October 29, 2001
LTR-NRC-01-37

Subject: Response to Request for Additional Information regarding "Addendum 1 Revision 1 of WCAP-12488-A / WCAP-14204-A, 'Westinghouse Fuel Criteria Evaluation Process'," (Proprietary / Non-proprietary)

**Response to Request for Additional Information regarding
“Addendum 1 Revision 1 of WCAP-12488-A / WCAP-14204-A,
‘Westinghouse Fuel Criteria Evaluation Process’,” (Proprietary / Non-proprietary)**

**REQUEST FOR ADDITIONAL INFORMATION WCAP-12488-A [WCAP-14204-A],
"WESTINGHOUSE FUEL CRITERIA EVALUATION PROCESS"
SUPPLEMENT 1
PROJECT NO. 694**

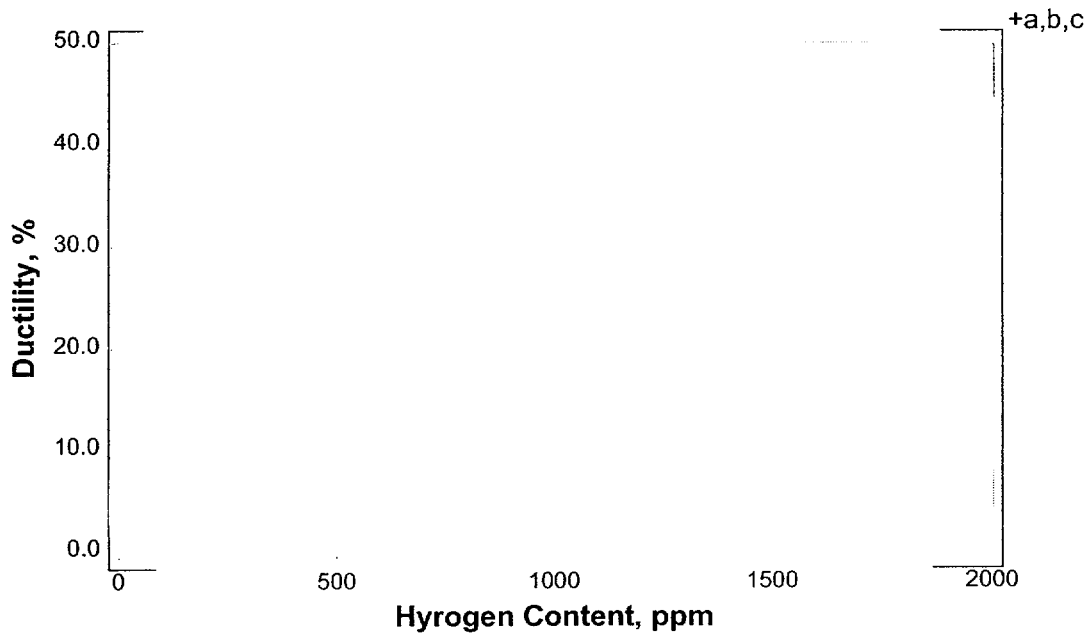
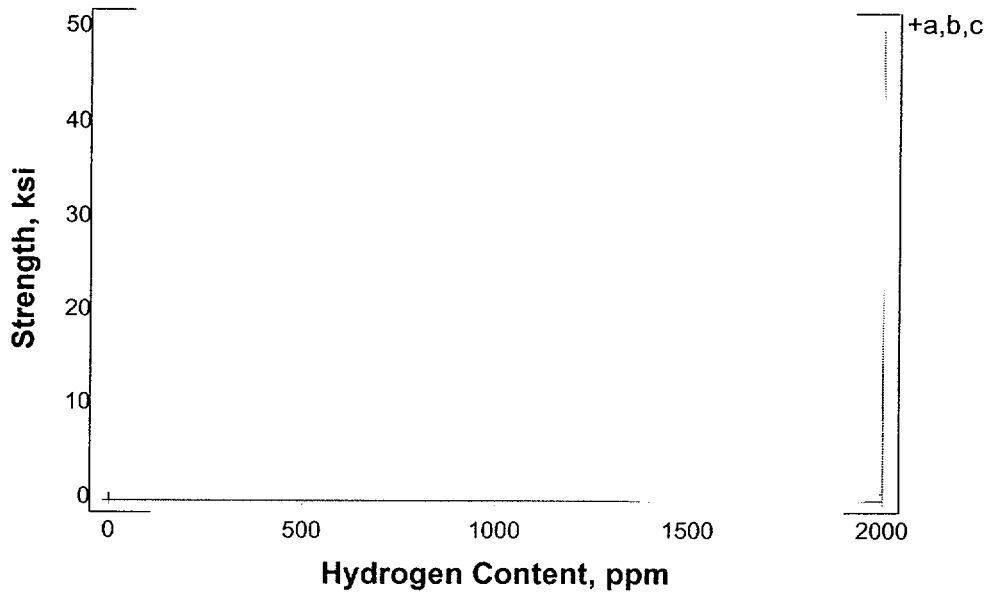
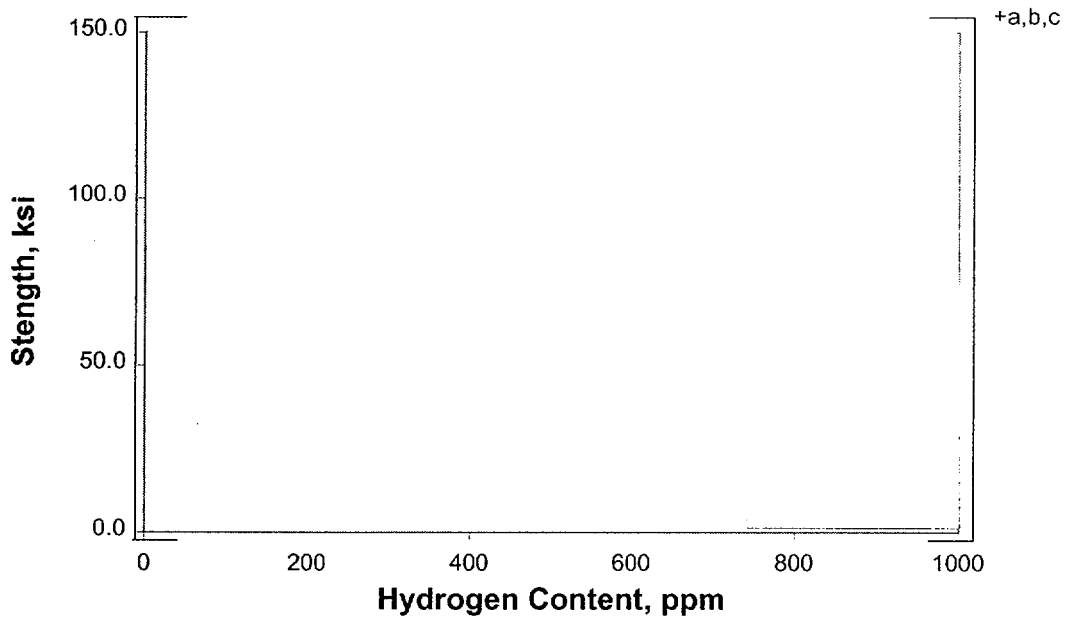
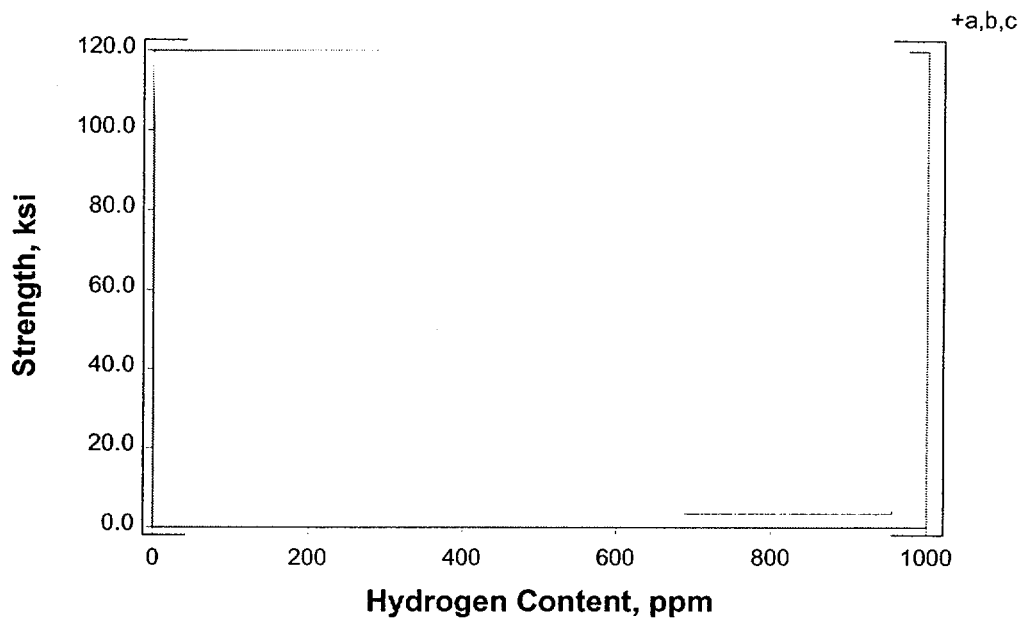
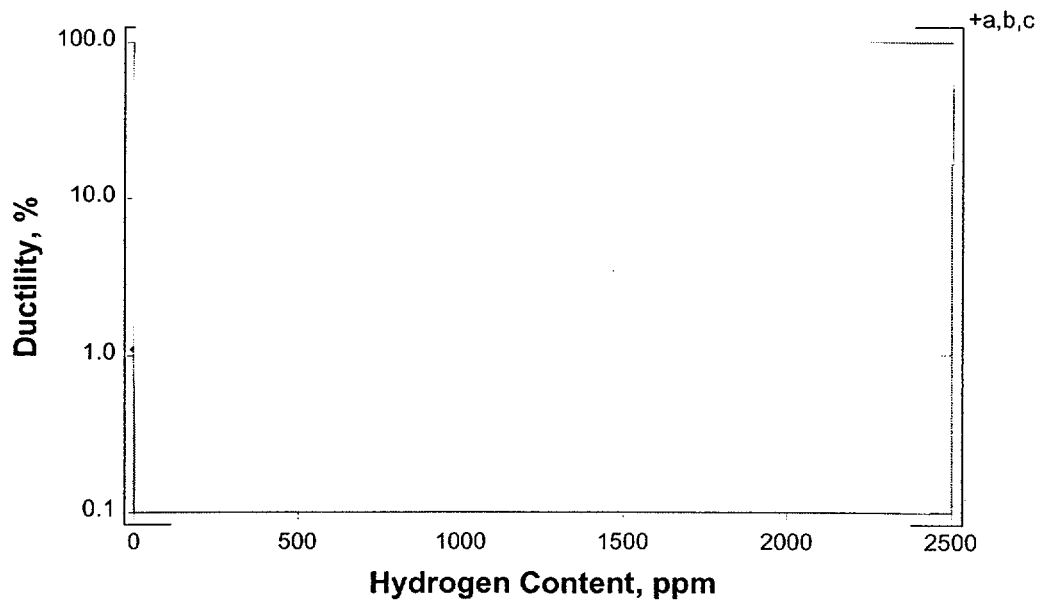
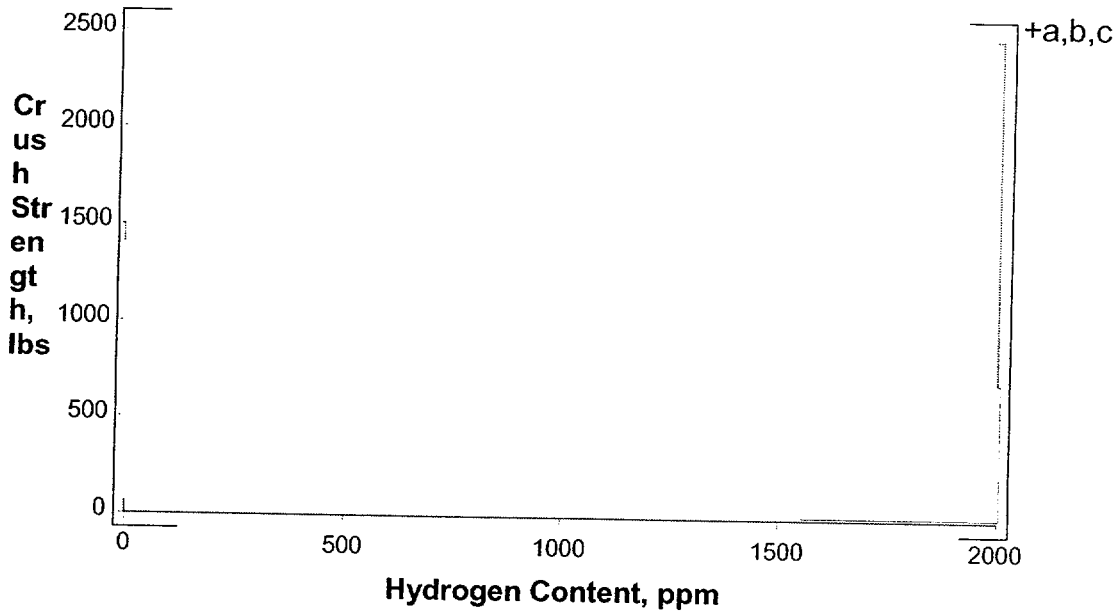
- b. 1st paragraph under "Effects of Hydrogen Content" subheading on page 2. "Westinghouse has conducted programs..." Reference cites are needed for the discussion under this heading and the figures that are provided.

Response 2b: Reference 12 has been added. Refer to the updated Addendum 1 Revision 1 with revision bars noting the changes (copy attached).
